## Addendum to the

# Apple II Reference Manual

The main logic board of your Apple has been modified to reduce electromagnetic interference. This means that it is different from the Apple boards which are described in the Apple II Reference Manual. It will not, however, behave differently in any specific way unless you have changes made to it.

**Replaces Figure 22-4. Schematic Diagram of the Apple II**

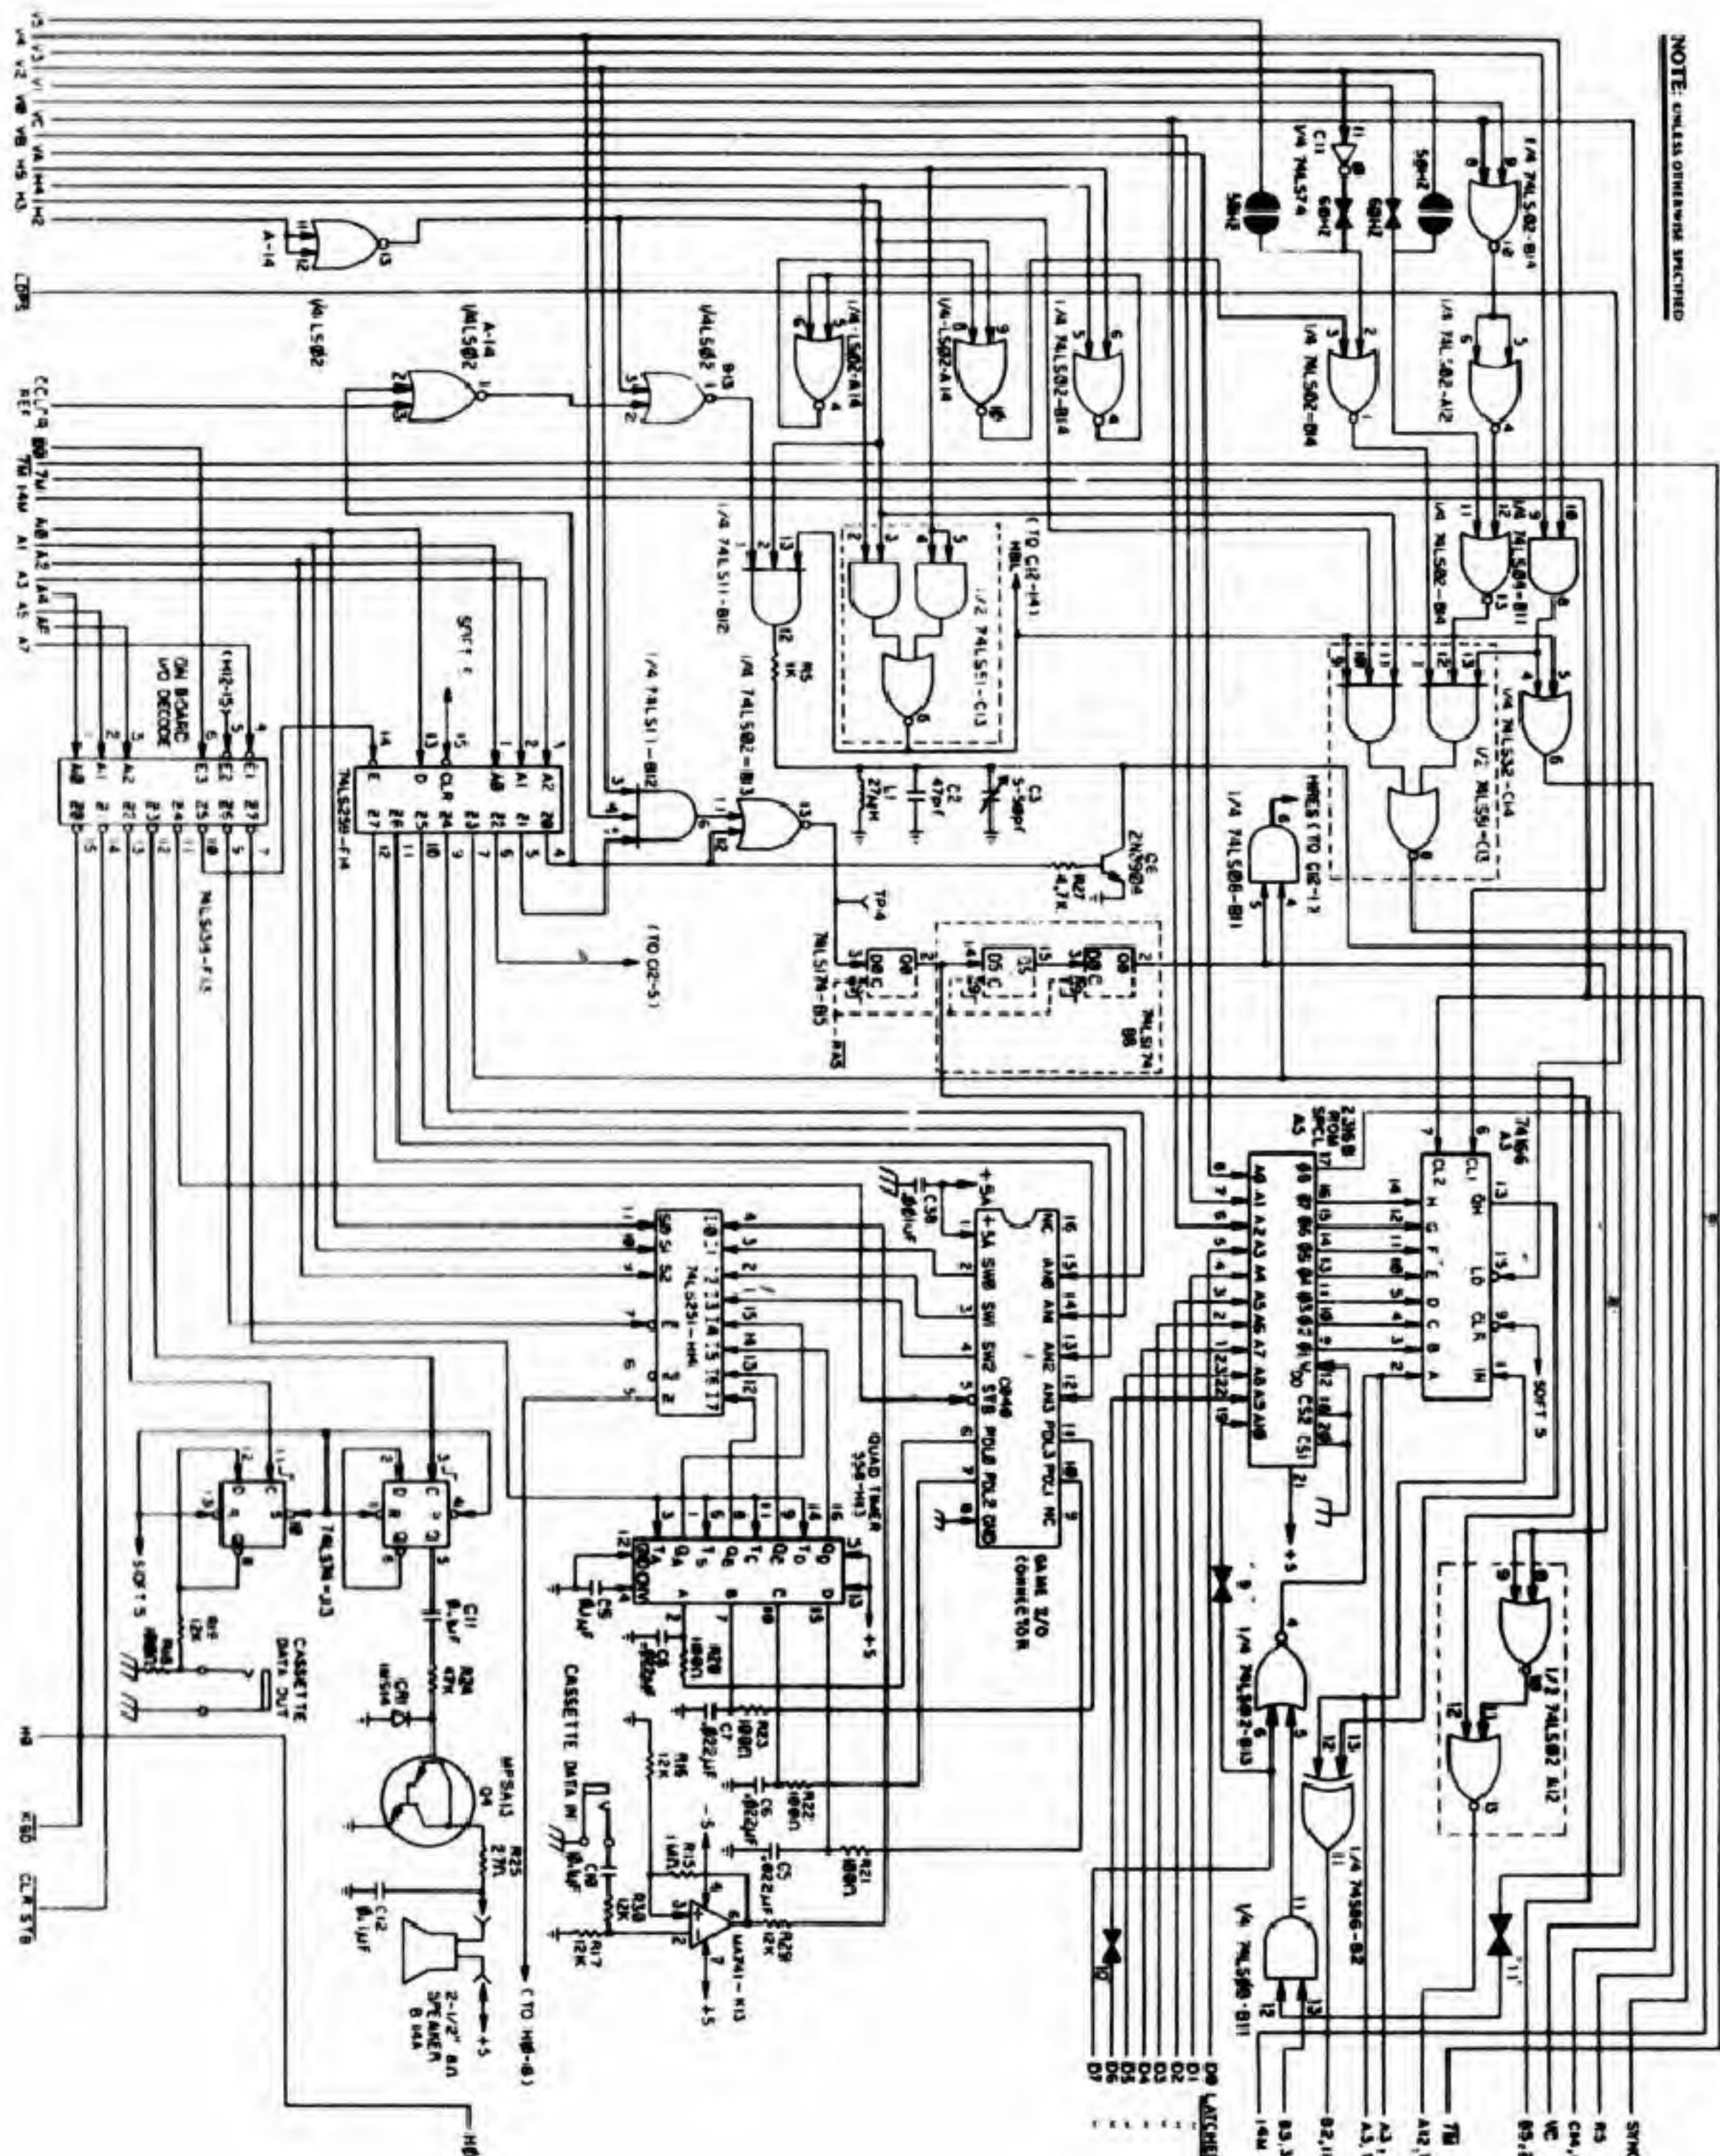
The major differences in the new main board are described below. Also, the attached schematics show the areas in which this board is different from earlier boards. You may wish to note these differences in your Apple II Reference manual, on the pages which correspond to the schematics here.

- \* The color killer circuit, which damps out the color burst when your Apple is in text mode, has an added cutout circuit. The color burst is cut off in the logic circuit before it gets to the tank circuit. This gives you good black and white text, even if your color monitor has a sensitive color burst detector.
- \* The power and ground system has been redesigned. The +5V and ground bus on the rear of the board have been interchanged so that the +5V bus is on the top of the board and the ground is on the bottom. A grounding bar has been added under the board to ensure electrical contact between the board and the metal baseplate. Additional filters have been added to further reduce the EMI emission levels.

**Replaces Figure 22-6. Schematic Diagram of the Apple II**

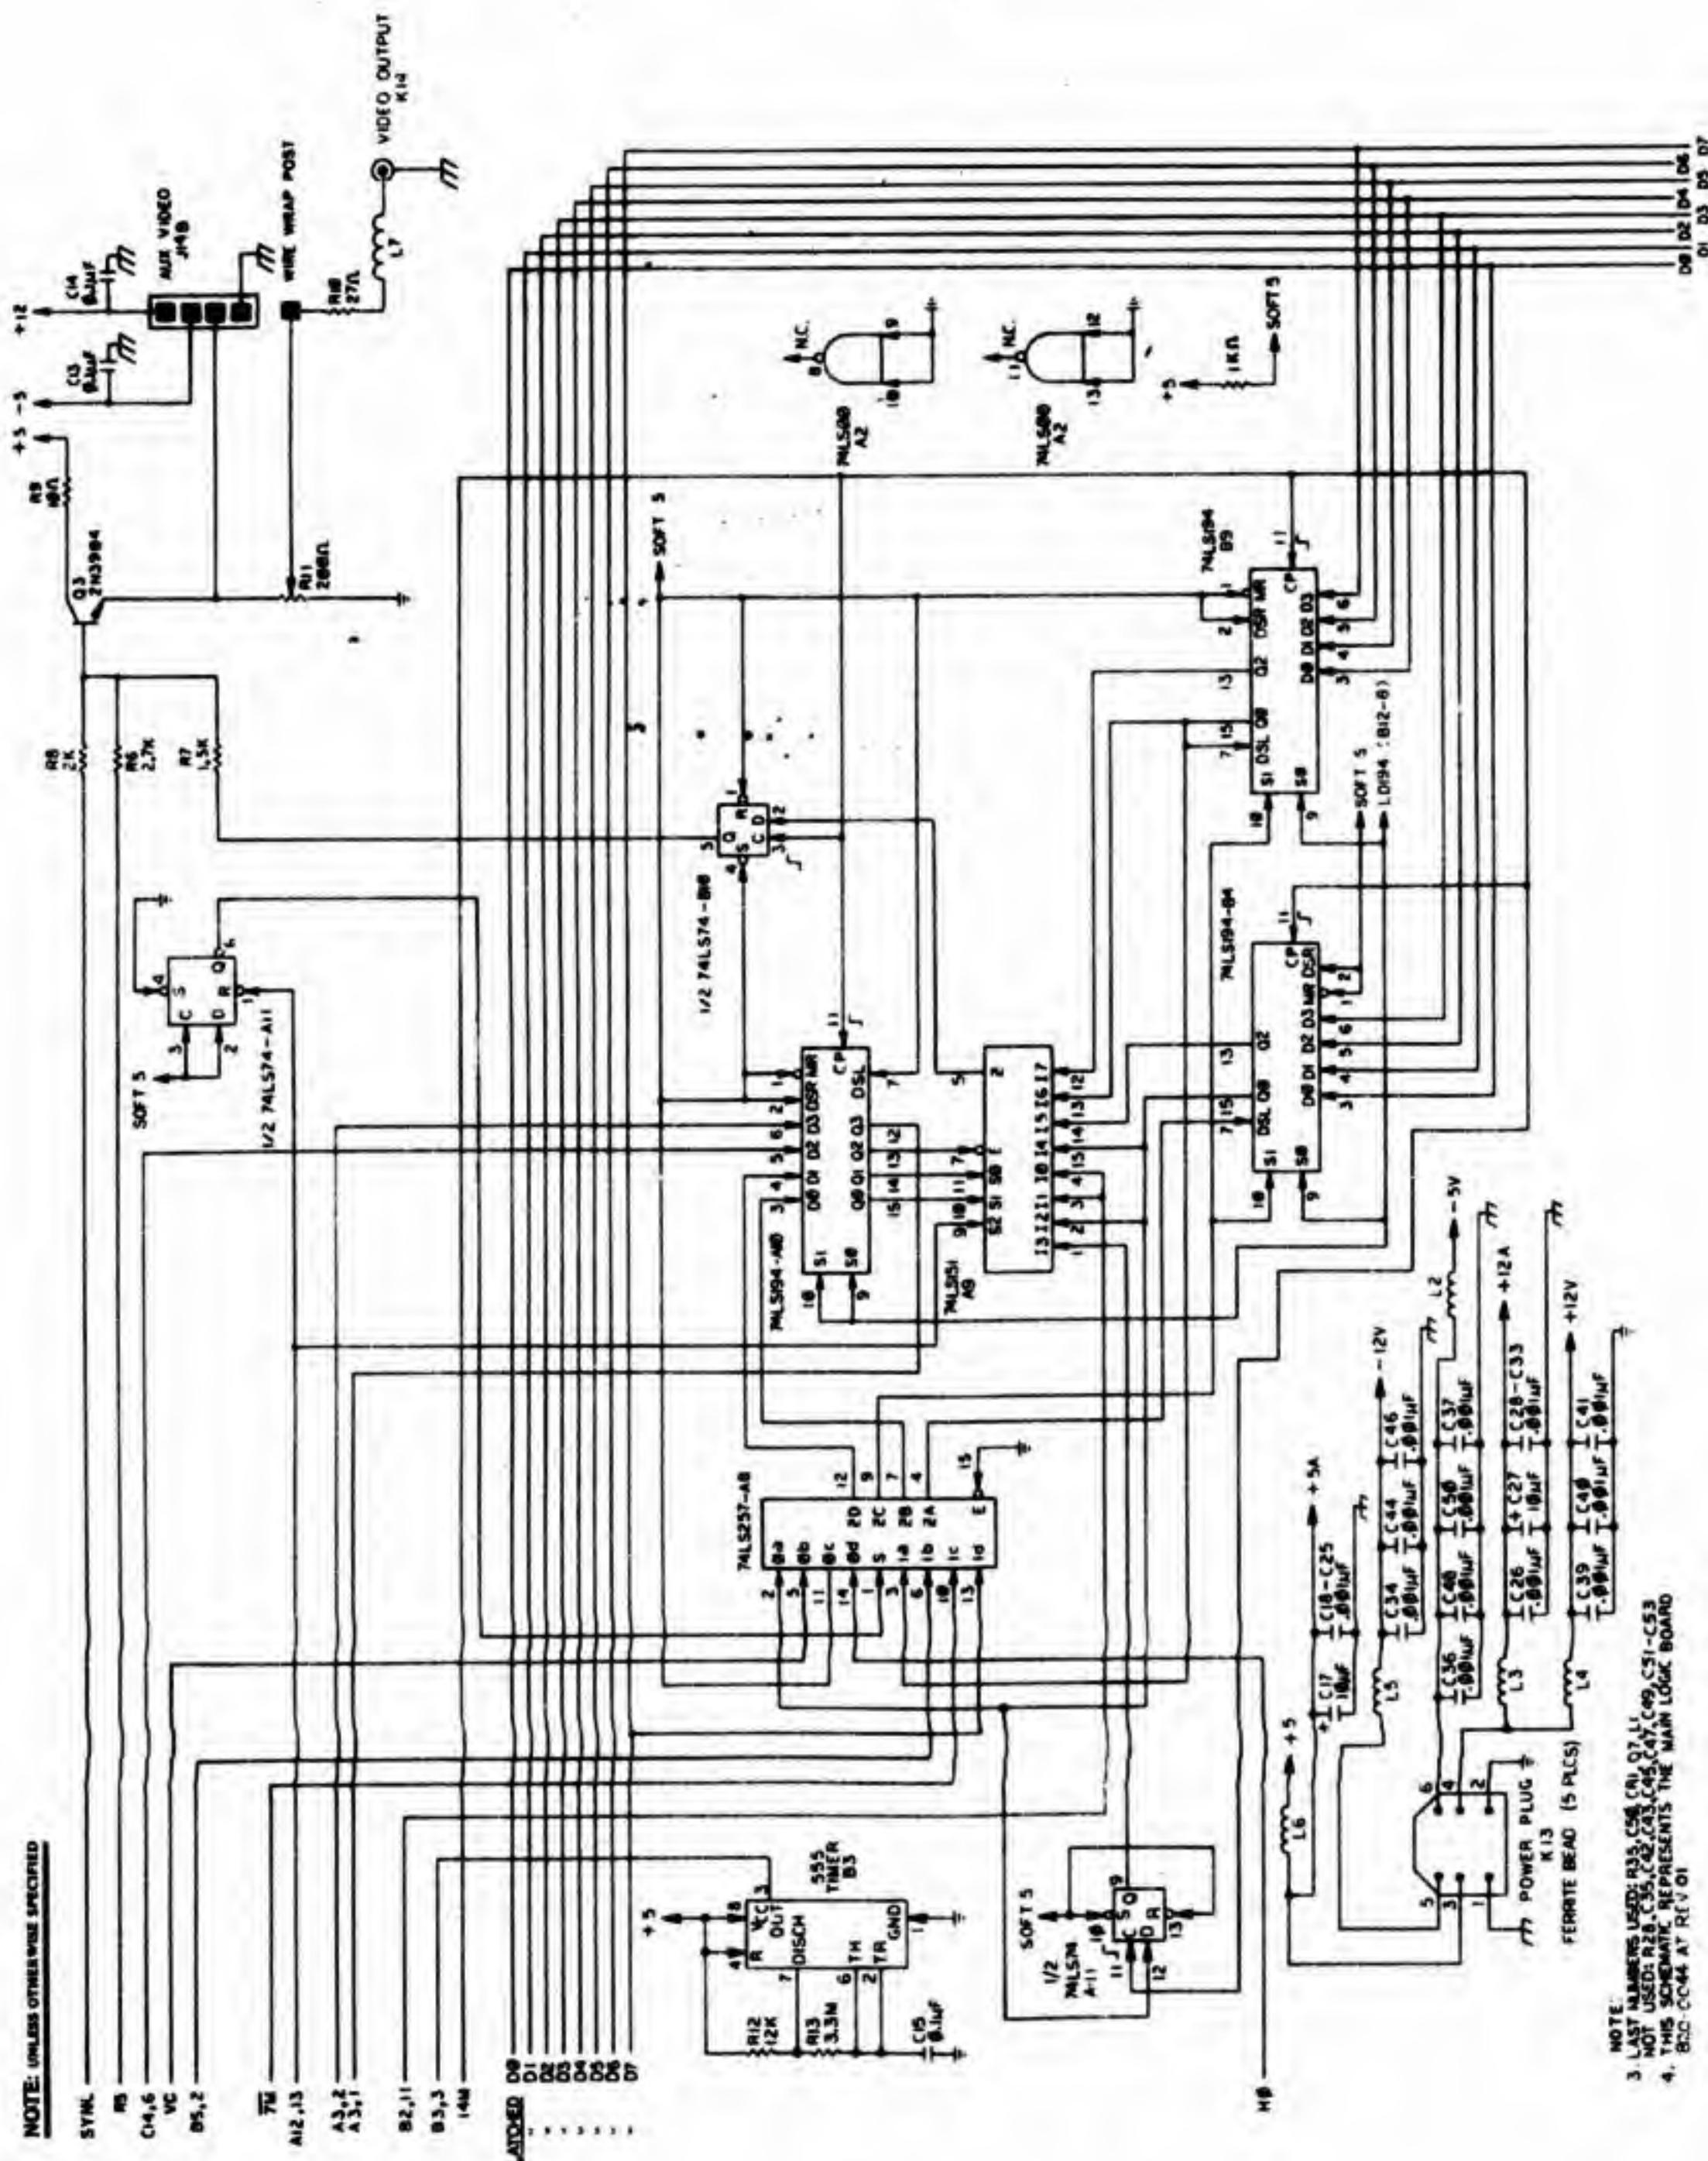
- \* This new board has a different character generator ROM IC. The character generator ROM IC determines what style of lettering, or character set, you'll see on your monitor or terminal screen. The new character generator ROM is found next to the Keyboard socket on the main board. This 2316B ROM has more space than the former 2513 character generator ROM, so that it's possible to have more than one character set available. The 2316B ROM can also be replaced with a 2716 EPROM, which allows you to program and change your own character sets.
